HYUNDAI Technical Service Bulletin	GROUP FUEL SYSTEM	NUMBER 20-FL-001H
	DATE February, 2020	MODEL(S) ELANTRA (AD/ADA)
SUBJECT:	DTC P0300/P0301/P0302/P0303/P0304 ECM SOFTWARE UPDATE AND IGNITION COIL INSPECTION/REPLACEMENT

This TSB supersedes TSB 19-FL-006H-1 with revised ECM software update and ignition coil external body appearance information.

Older Style Ignition Coil External Body Appearance:

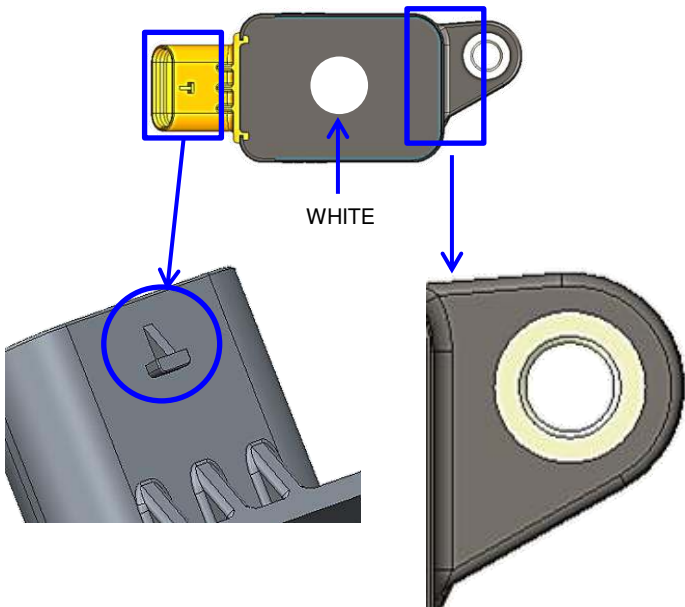
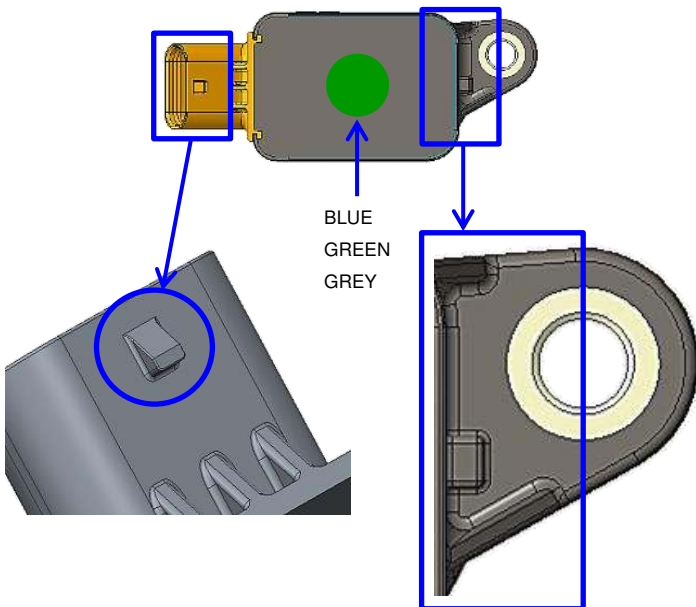
PART NAME	PART NUMBER	REMARKS
IGNITION COIL	27300-2E601 Older Style  Replacement ignition coil with previous shaft design Newer Style  Replacement ignition coil with updated shaft design	- Both the older and newer ignition coil shaft styles are interchangeable. - Color marking inspection does not apply to the newer style ignition coil with updated shaft design. - Replace if the vehicle ignition coil is the older style and has a WHITE or BLUE mark on top. - Do not replace if the vehicle ignition coil is the older style and has a GREEN or GREY mark on top.

Older Style Ignition coil with WHITE Mark	Older Style Ignition coil with BLUE/GREEN/GREY Mark
